SR 38/US 84 WIDENING
EDS-84(23) and BHN-007-3(25), Clinch/Ware Counties
P.I. Nos. 422120, 422125

Value Engineering Study Report
Preliminary Design Stage

July 2007

re: Project Numbers EDS-84(23) and BHN-007-3(25), US 84/SR 38 Widening and Reconstruction,
Clinch and Ware Counties
Value Engineering Study Report

ALTERNATIVE NO.: **2**

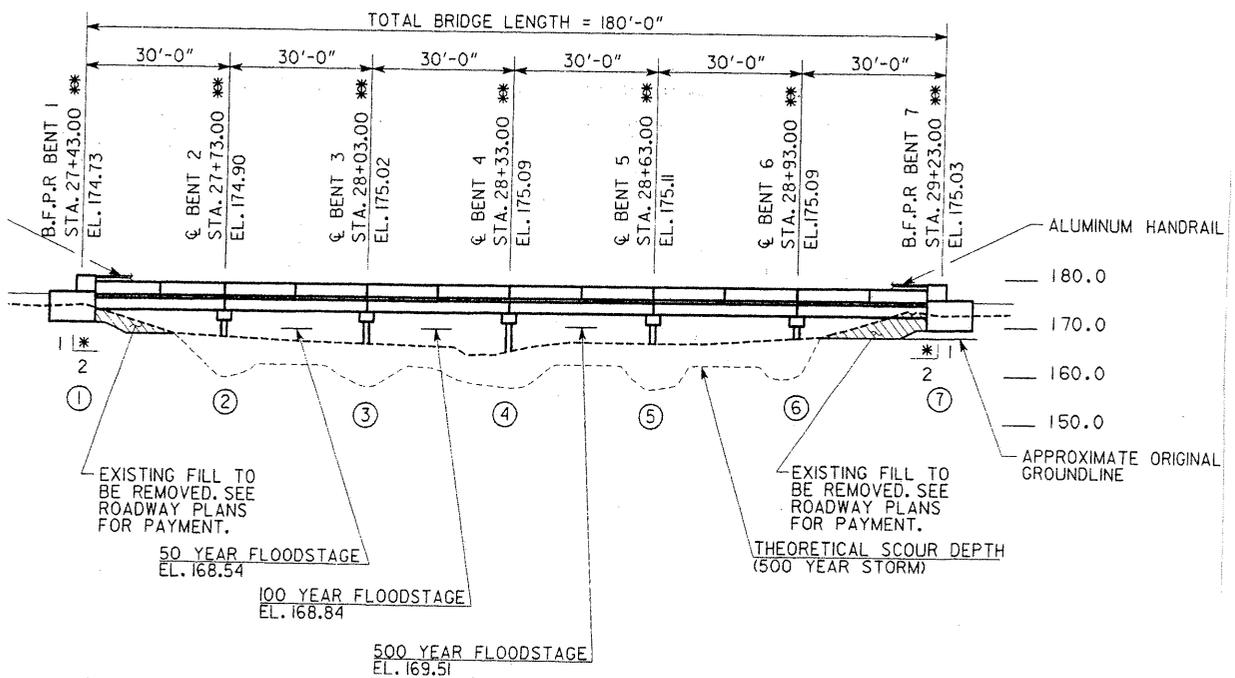
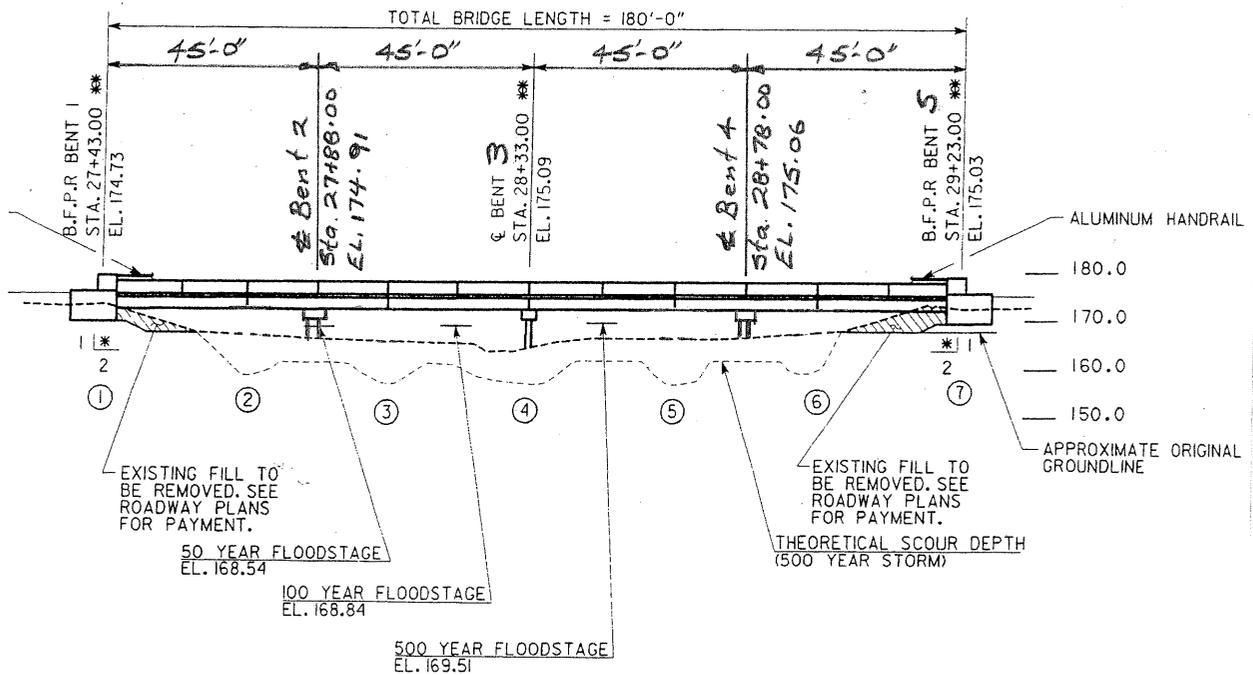
Use a four-span (45-ft. each) bridge with prestressed concrete (PSC) beams (Type I modified) and pile bents.

Even though it will increase the initial cost to implement this alternative, the duration of construction will be reduced, and past records have shown that contractors prefer Type I modified PSC beams vs. T-beams.

3B

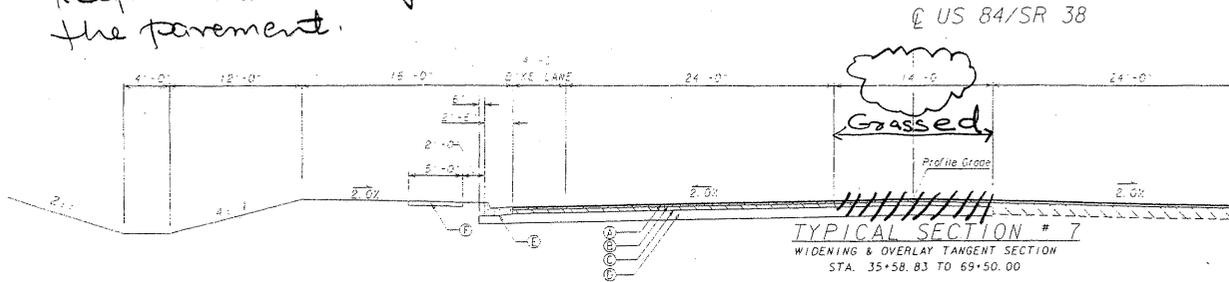
Eliminate the pavement from the median between STA 29+23.00 and 72+56.00 and provide grassing in this area.

- Increases cost to provide turning lanes in the future (if ever needed)

4

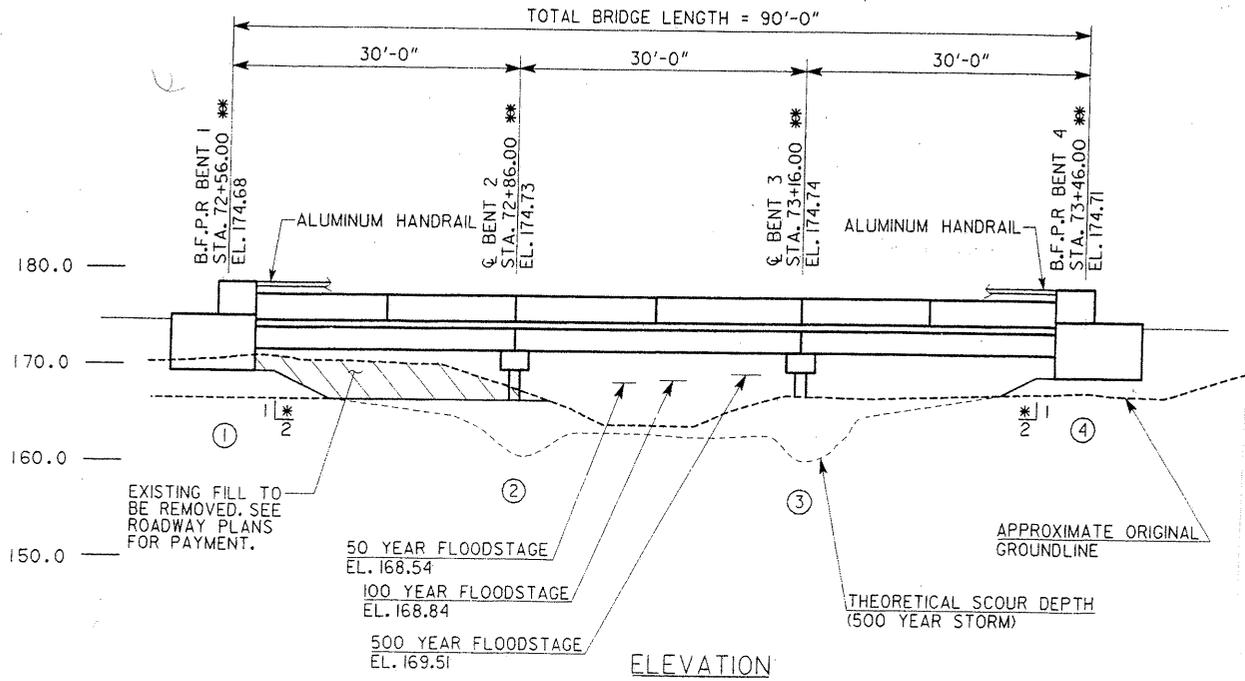
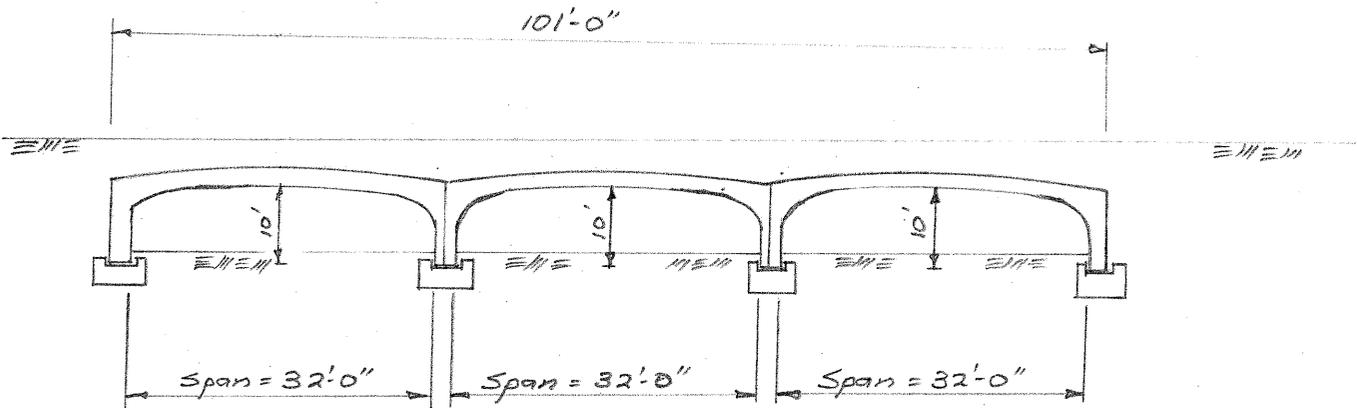
DESCRIPTION: **REPLACE THE EXISTING THREE SPAN BRIDGES WITH**
THREE CON/SPAN® CULVERTS AT BRIDGE NO. 2 –OVER
WOODYARD CREEK OVERFLOW

Although Con/Span® is addressed with this alternative, other manufacturers are available that can provide similar products.

9

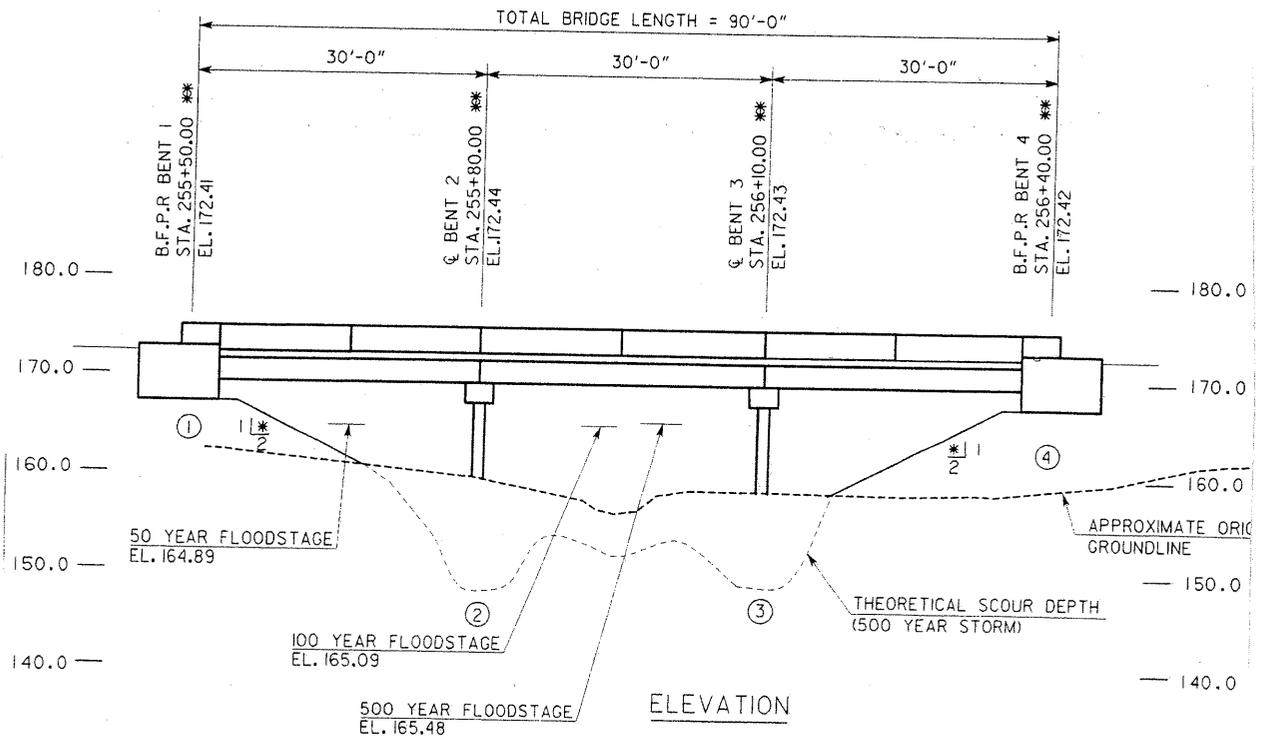
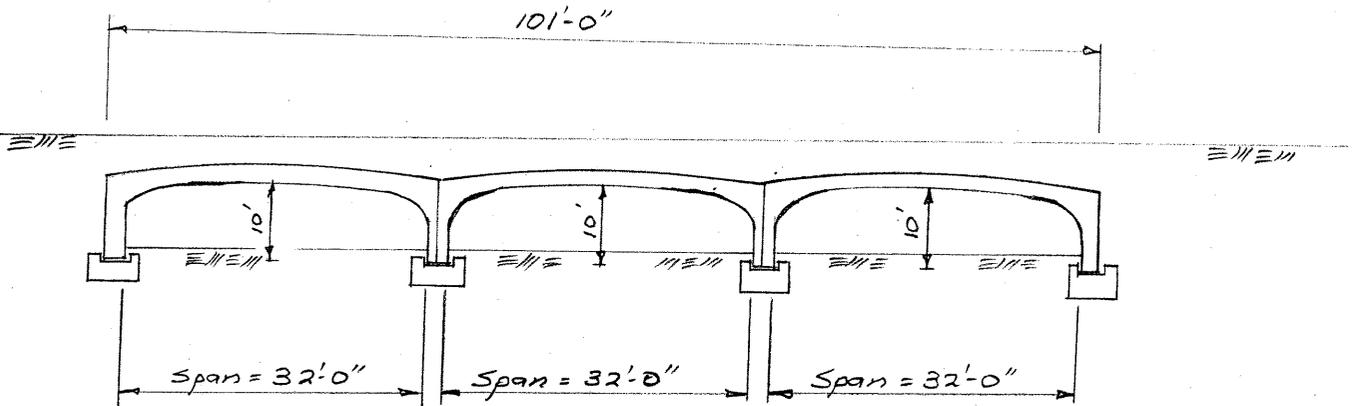
DESCRIPTION: **REPLACE THE EXISTING THREE-SPAN BRIDGES WITH**
THREE CONSPAN[®] CULVERTS AT BRIDGE NO. 4 OVER
PETERS BRANCH

Although Con/Span[®] is addressed with this alternative, other manufacturers are available that can provide similar products.

ALTERNATIVE NO.: 10
 SHEET NO.: 4 of 5

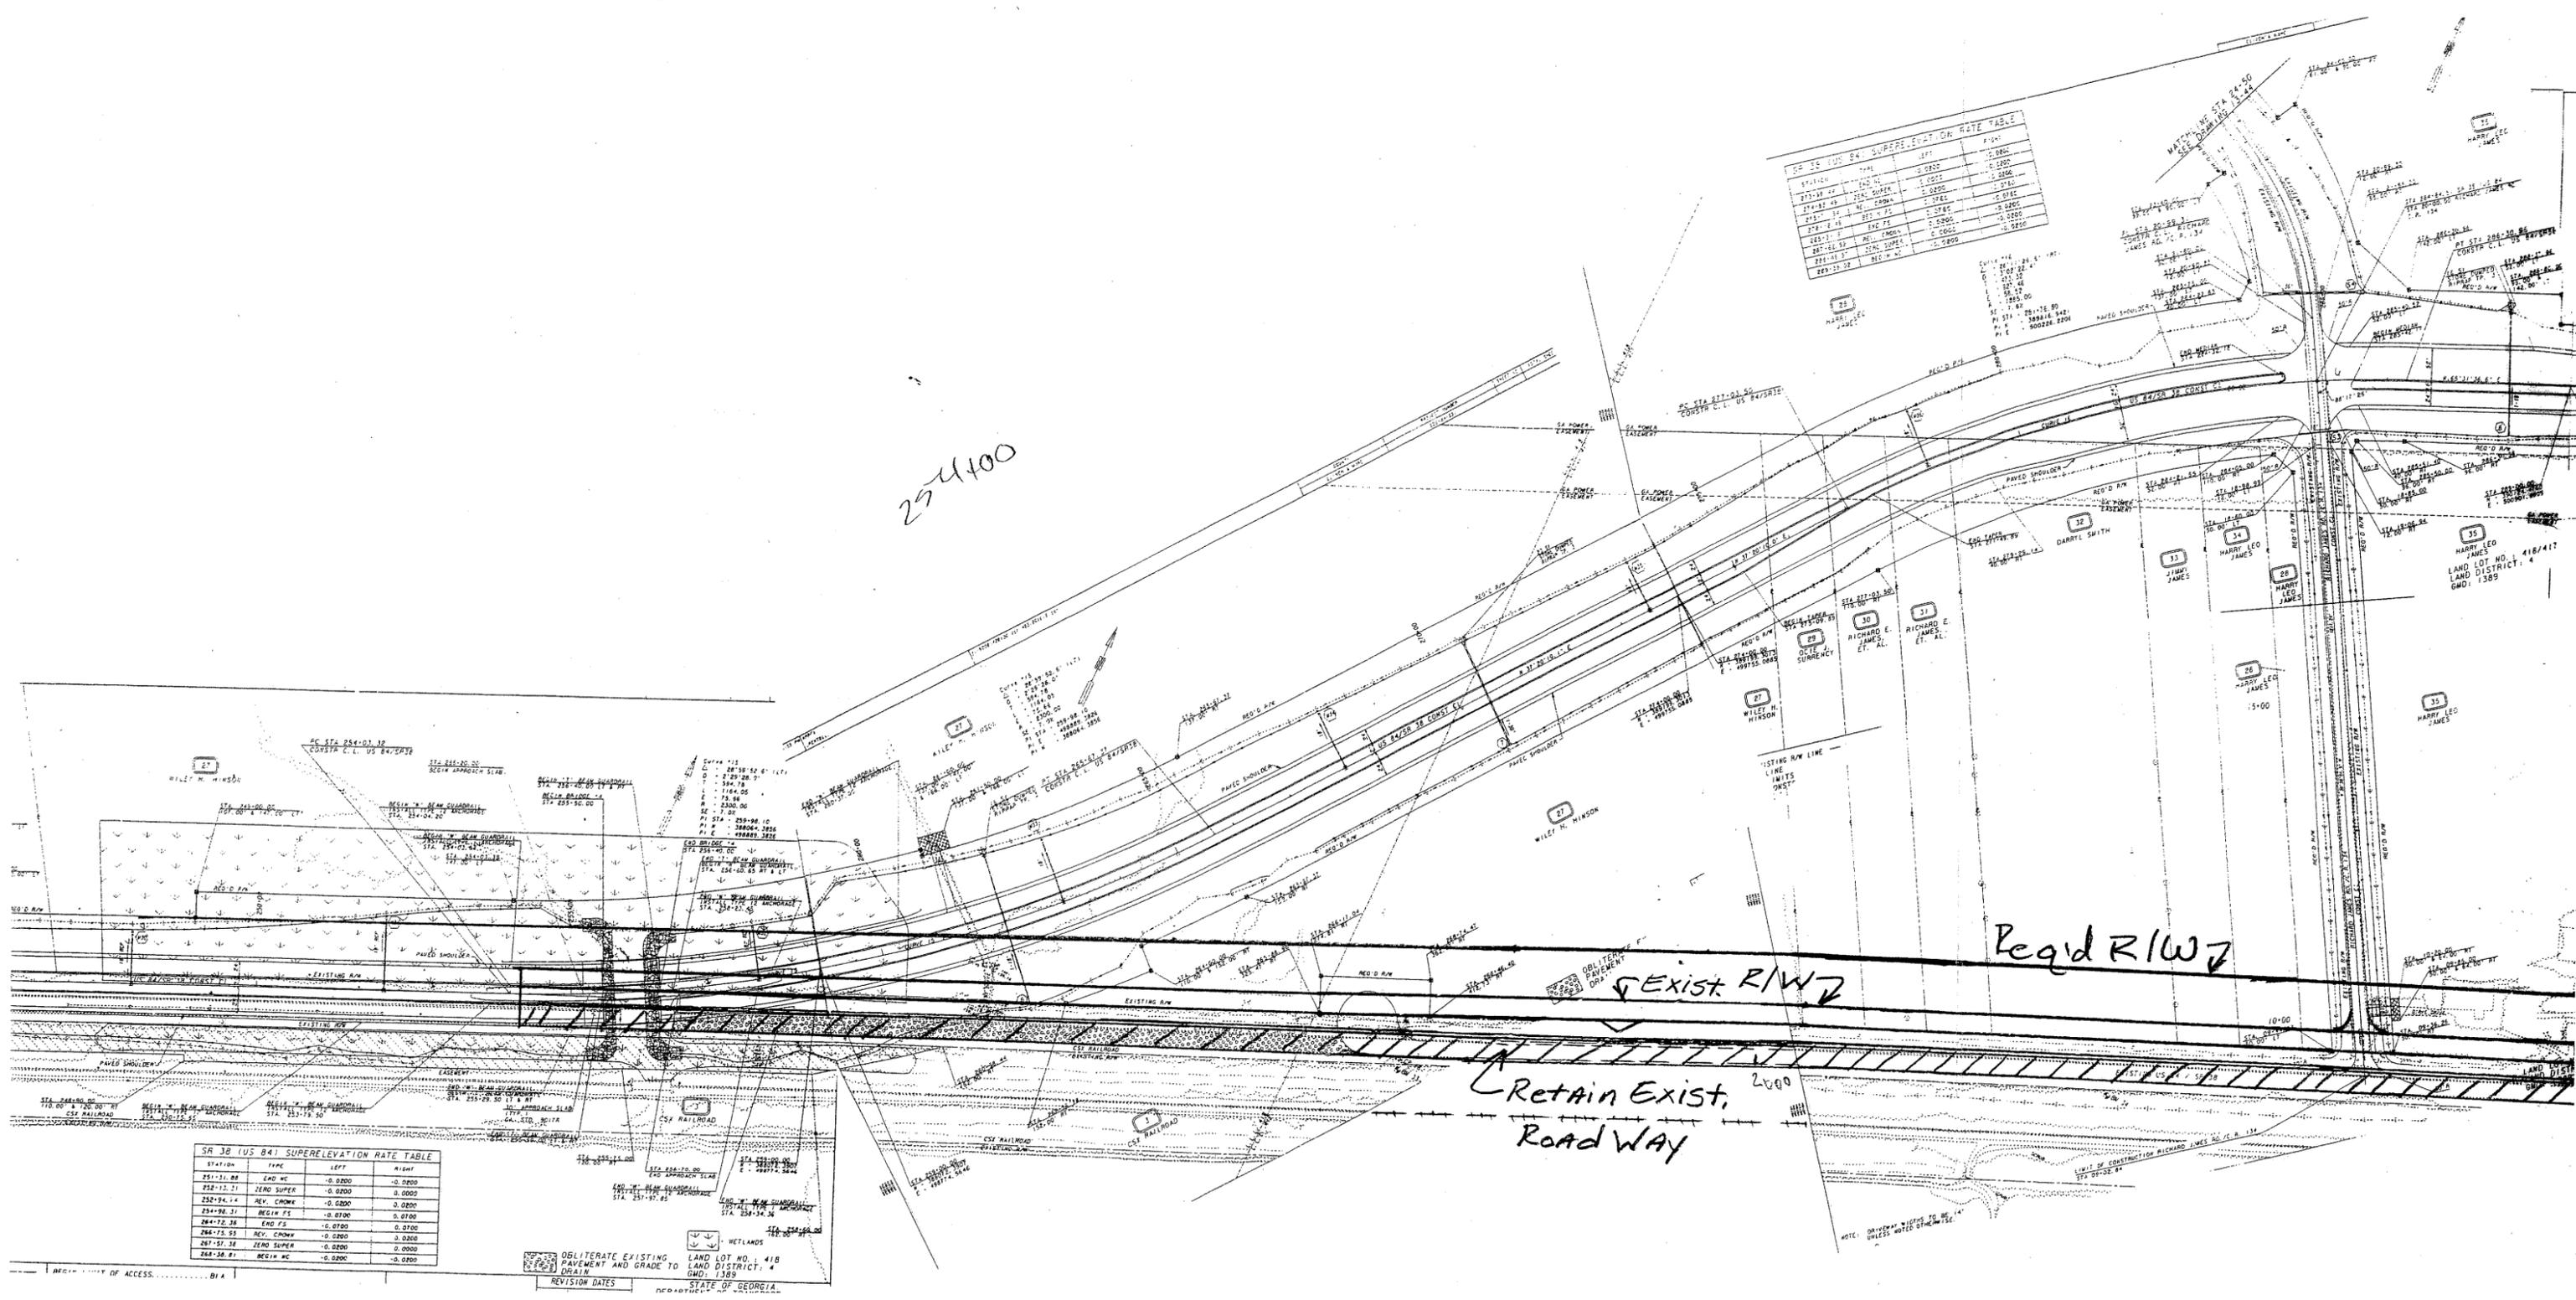
OBLITERATE EXISTING PAVEMENT AND GRADE TO DRAIN
STATE OF GEORGIA
LAND LOT NO. 418
LAND DISTRICT: 4
GMD: 1389

Figure 9: Improvements at Hall-Parlor House in Argyle

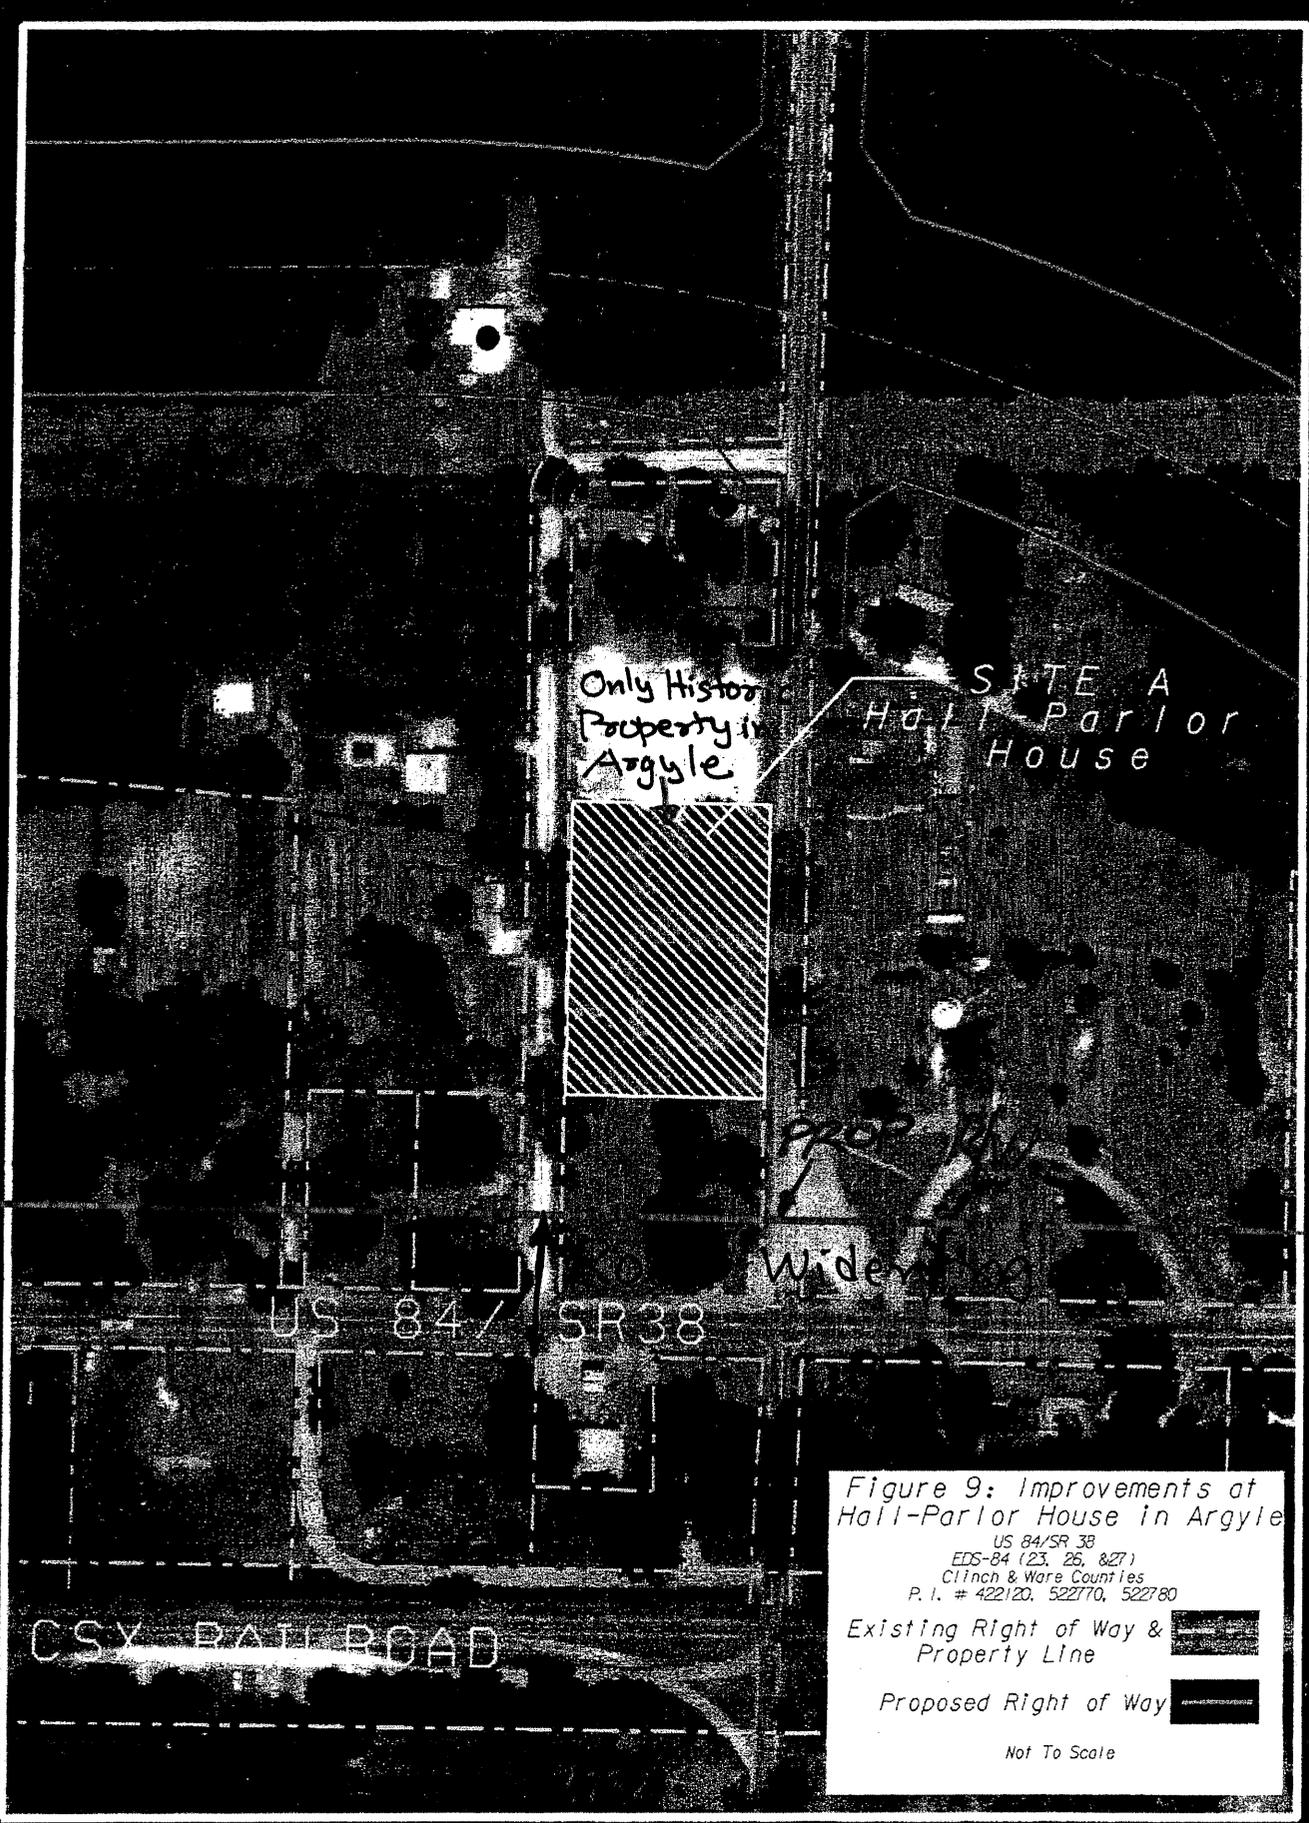
Proposed Alternate Road Widening

Only Historic Property in Argyle

✓ Hall-Parlor House in Argyle - is a ca. 1915-1925 Hall-Parlor, with no apparent academic style, that is located in Argyle on the southwest side of CR 128, approximately 250 feet west of the intersection of CR 128 and US 84/SR 38 (refer to *Existing/Proposed Right-of-Way at the Hall-Parlor House in Argyle*, Figure 9). The property retains its original materials and features including brick pier foundation, exposed rafter tails, six-over-six double-hung windows, and a gable end chimney. Alterations to the property include a ca. 1935-1945 rear gabled addition and nonhistoric wood siding dating to ca. 1955-1965. A small, one-bay garage from ca. 1940-1950 is also located on the property.
